P&Z STAFF REPORT

Board of Appeals Meeting, February 11, 2020

Case: **V20-0003 – 1625 Sunnybrook Farm Road & 0 & 1220 Tynecastle Way NE**
Staff Contact: Madalyn Smith (msmith@sandyspringsga.gov)
Report Date: January 29, 2020

Requests for a Variance from Sec. 9.2.4.A. at 1625 Sunnybrook Farm Road & 0 & 1220 Tynecastle Way NE:

Limits of the wetlands area

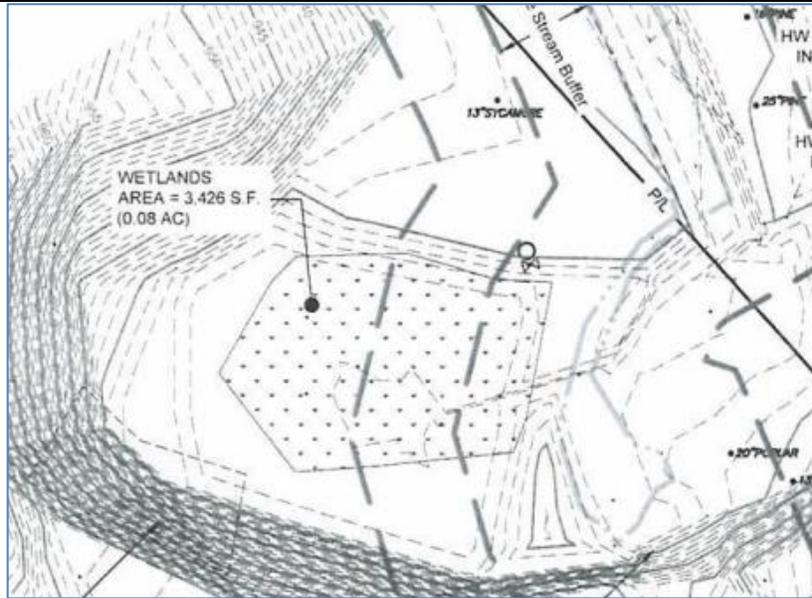
Finding: The 50-foot buffer and 25-foot setback area proposed to be disturbed is currently wooded and sloping. There is also a former quarry area with a sheer cliff. The quarry area has a 3,426-square foot wetland, as identified by the Army Corps of Engineers, which spans the buffer and setback area (see plan below).
